AIRPORT ZONING BOARD OF ADJUSTMENT

CITY OF BAY CITY

- 2. Appeal by RWE Peyton Creek Wind Farm II, LLC of Administrative Agency's denial of five (5) permits and alternatively a request for variance for the placement of five (5) Wind Turbine Sites.**
- 3. Potential closed meeting as authorized by Texas Government Code §551.071(1) to confer with its attorney regarding contemplated litigation; or (2) matters covered by the attorney client privilege.**
- 4. Return to open session and take any action regarding matters discussed in closed session.**

PLAN: TURBINES PC2-167, PC2-179A, PC2-185 & PC2-213

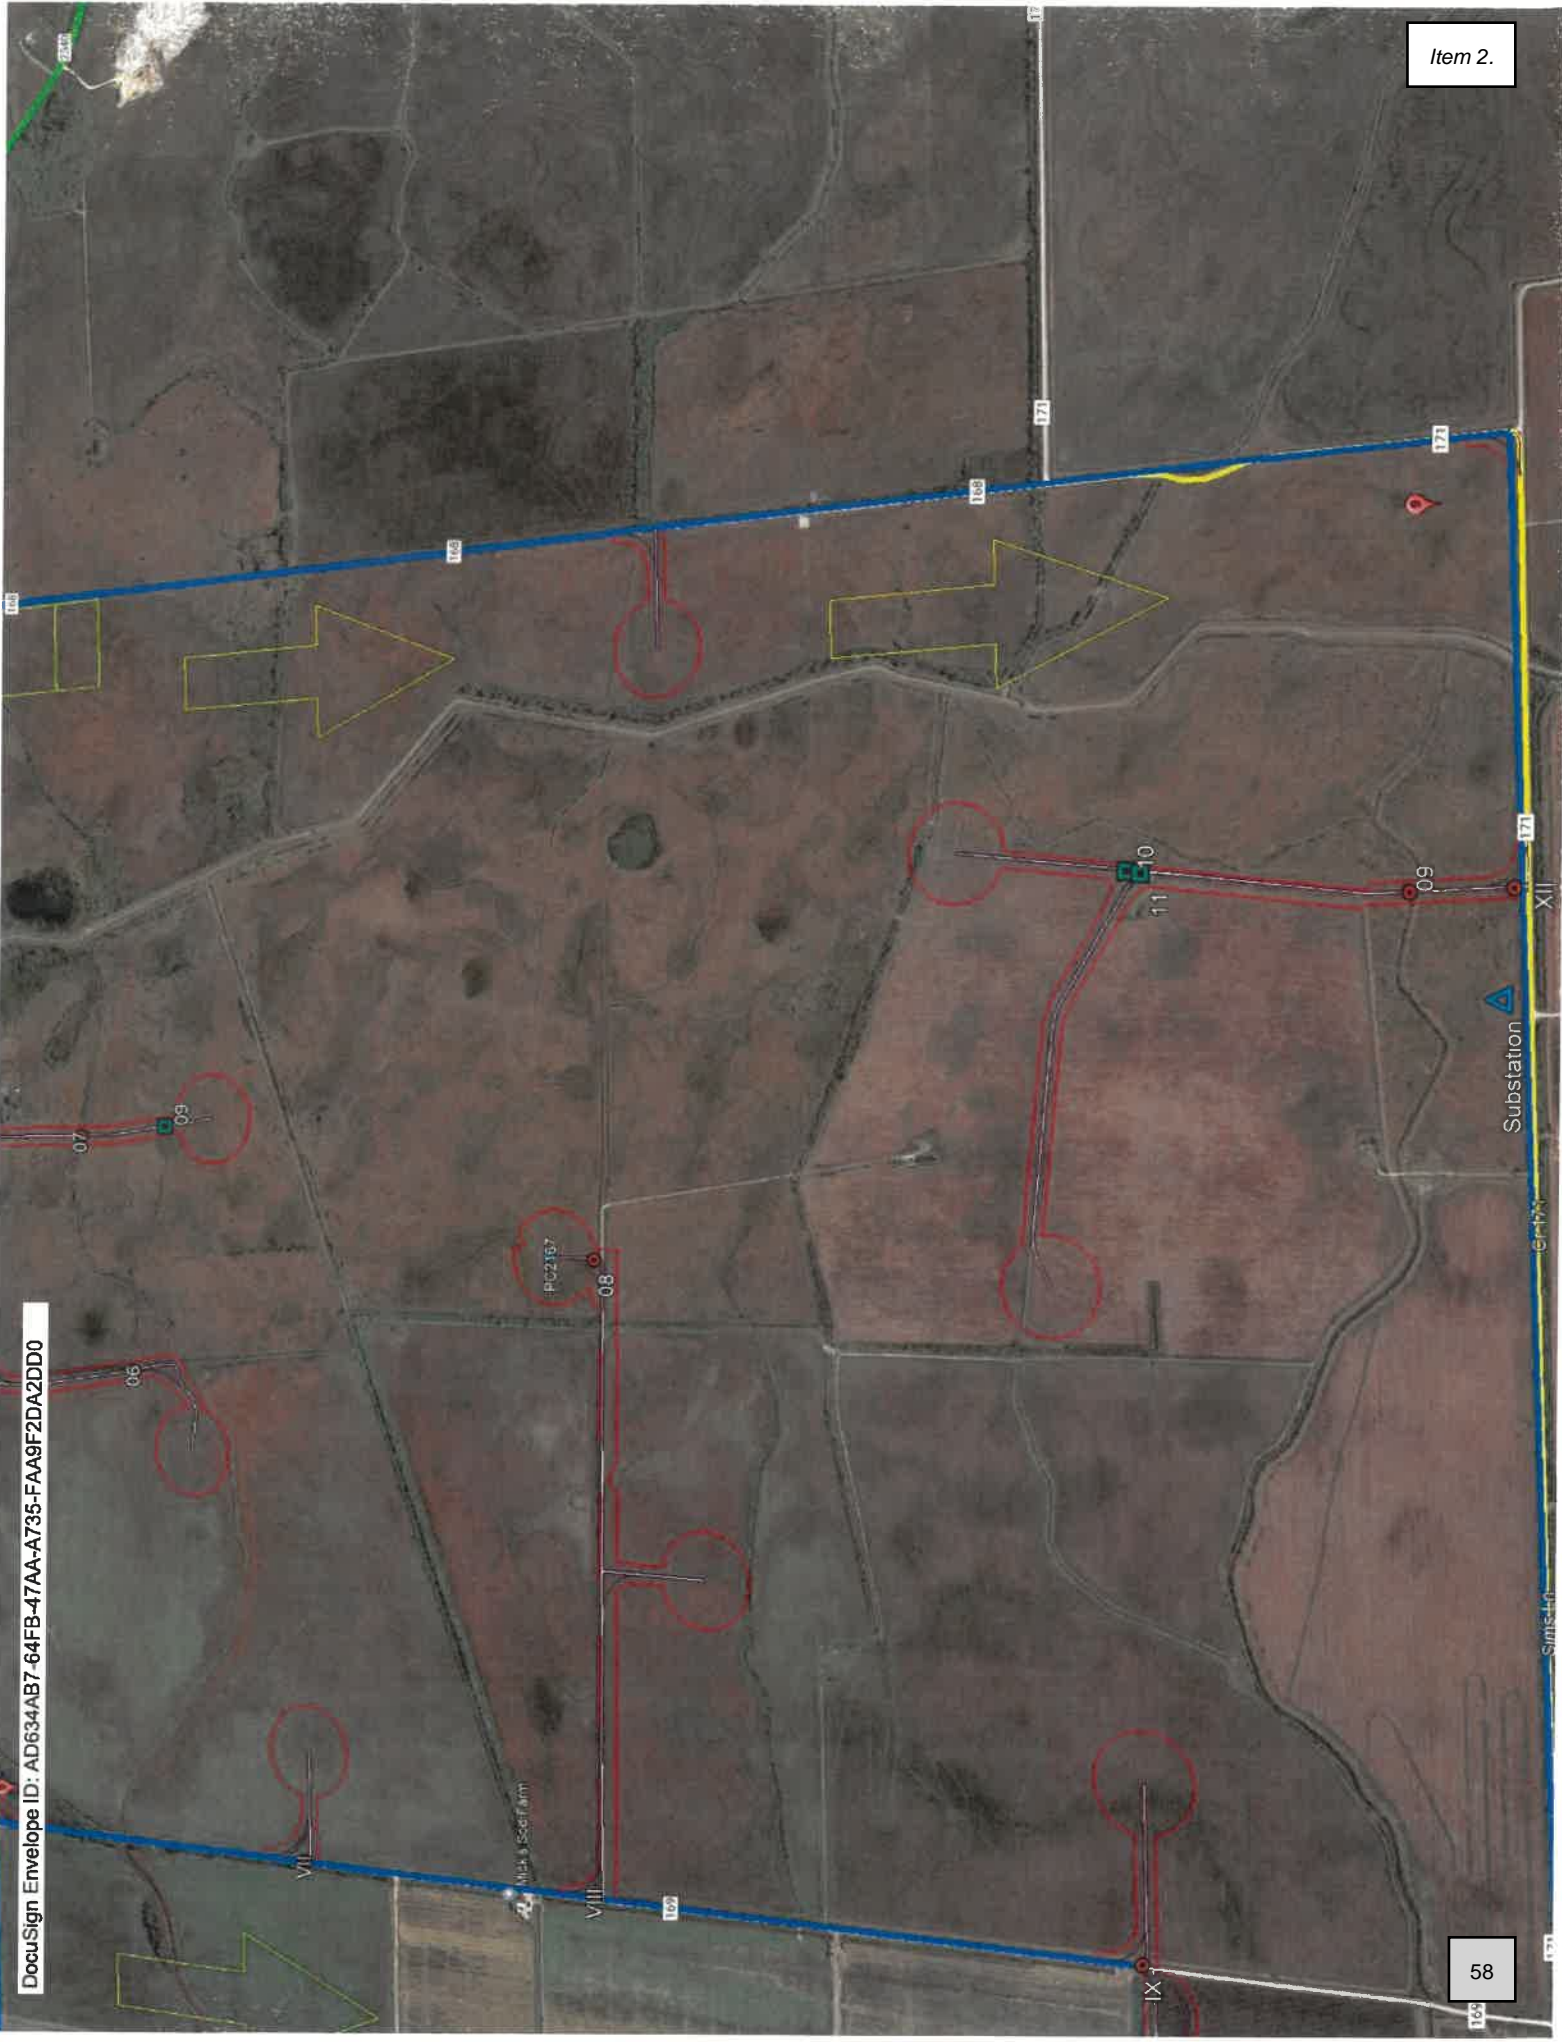
Is project consistent with the Airport Zoning Regulation: Yes _____ No X

Reason for project not being considered consistent with zoning regulation:
INCREASE TIME-OUT MINIMUMS FOR OBSTACLE DEPARTURE PROCEDURES

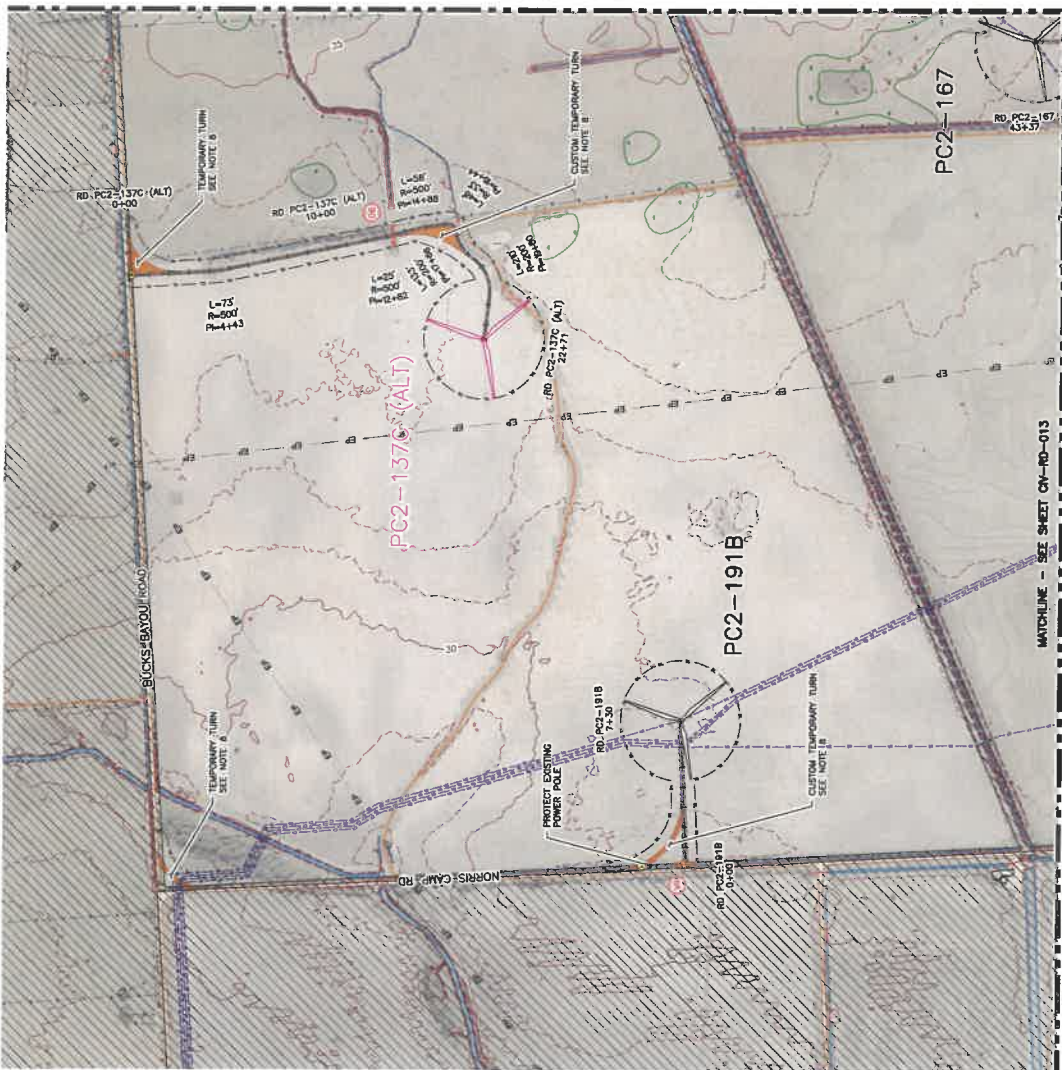
Is project consistent with the Airport Zoning Regulation: Yes _____ No X

Reason for project not being considered consistent with zoning regulation:
PLEASE TAKE OFF MARSHES & OBSTACLE Diagram provided.
